Application Note Bankswitch TR4 and TR16 Hardware Modification

Photo 1

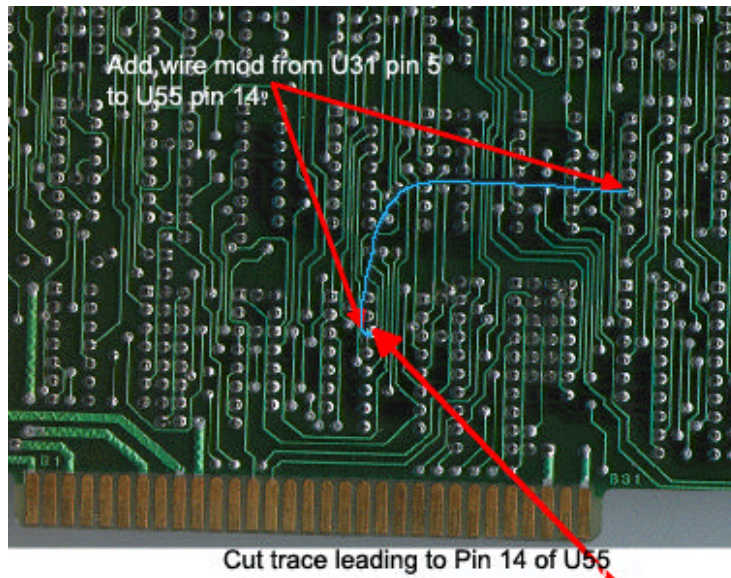
Problem: Timing of signal was too short in duration to the clocking operation.

Details of hardware modification: See photo 1

Solution: Use the BCOND signal that feeds the GOTB latch circuit to match the clocking signal.

- 1) On the solder side of the PCB cut the trace leading to pin 14 of U55, leaving the trace between pins 14 and 13 intact.
- 2) Add a wire from U31 pin 5 to U55 pin 14.
